THE RESERVES at EAGLE POINT

385 NORTH PICADILLY RD - BUILDING C

City of Aurora Building Division
Reviewed for Code Compliance
Approved as Noted: *Matt A.*
Date: *Nov 28, 2023*
2021 INTERNATIONAL CODES & 2023 NEC

3 TYPICAL 3 BEDROOM - WASTE AND VENT ISOMETRIC
No Scale

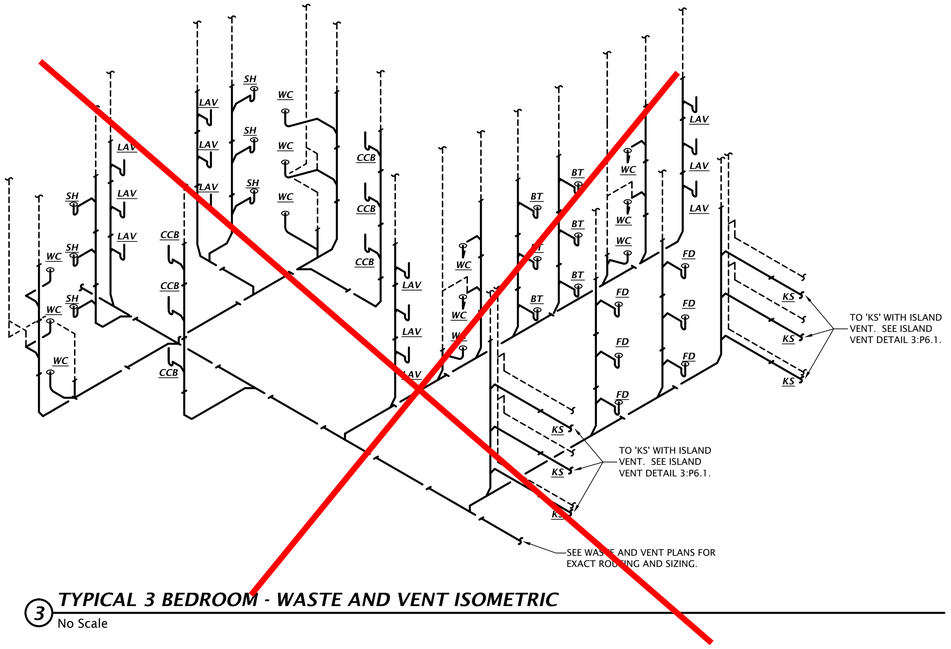
The dry vent must rise 6" vertically above the flood level rim of the highest trapped fixture being vented.
2021 IPC 905.4
